Access Compliance Report

Public Rights-of-Way

(Curb Ramps)

Intersection ID: 49702	Main Street: SCOTTSMAN_TRACE_DR	Cross Street: MILL_RIVER_LN	Location: SW
ADA ID: 96950C6389C5	Ramp Type: PerpDiag	Initial Pass/Fail: Fail	Overall Compliance: No
Codes/Mitigation Info/Possible Solution		Field Measurements/Component Compliance

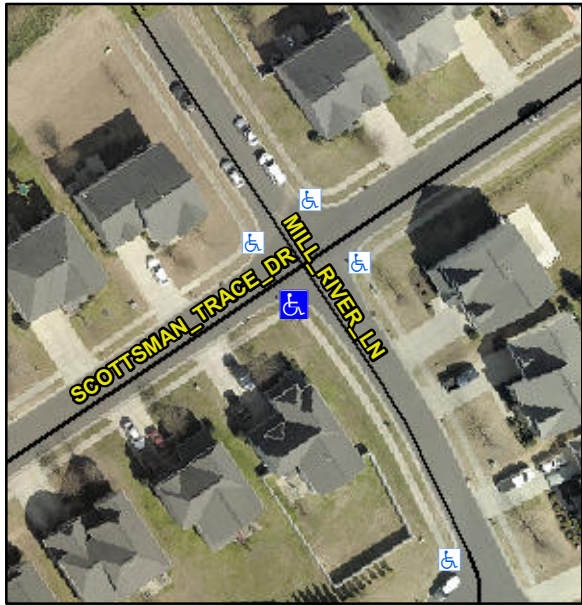
Possible Solutions:												
	Remove & Replace Curb Ramp With Two New Directional Ramps or Equivalent.												
	Surveyor Notes:												
	N/A												
	PROW/ADA:												
	Not Found, R304.5.1, R304.5.3												
Street 1 Name	MILL RIVER LN												
Stop Condition-Street 2	StopSign												
Street 2 Name	SCOTTMANS TRACE DR												
Stop Condition-Street 1	None												
Total Cost:		\$	3200.00

Compliance	Description	Data	Compliance	Description	Data
N/A	Ramp Length (in)	45.0	Yes	Ramp Slope (%)	7.6
No	Ramp Width (in)	46.0	No	Ramp XSlope (%)	5.9
N/A	Flare Type LT	N/A	N/A	Flare Type RT	N/A
N/A	Flare Slope LT (%)	N/A	N/A	Flare Slope RT (%)	N/A
N/A	Flare Traversable LT?	N/A	N/A	Flare Traversable RT?	N/A
N/A	Landing Length (in)	N/A	N/A	DWS Provided?	N/A
N/A	Landing Width (in)	N/A	N/A	DWS Contrast?	N/A
N/A	Landing Slope (%)	N/A	N/A	DWS Length (in)	N/A
N/A	Landing X Slope (%)	N/A	N/A	DWS Full Width?	N/A
N/A	Landing Curb? (Y/N)	N/A	N/A	DWS Offset (in)	N/A
N/A	Shared Landing?	N/A			
N/A	Gutter Ponding?	N/A	N/A	Gutter Slope (%)	N/A
N/A	Gutter Lip Ht (in)	N/A	N/A	Gutter X Slope (%)	N/A
N/A	Painted X Walk1?	No	N/A	Painted X Walk2?	No
	X Walk 1 Direction	To NE		X Walk 2 Direction	To NW
N/A	X Walk 1 Width (in)	N/A	N/A	X Walk 2 Width (in)	N/A
	X Walk 1 Slope (%)	3.4		X Walk 2 Slope (%)	1.5
	X Walk 1 X Slope (%)	3.1		X Walk 2 X Slope (%)	4.0
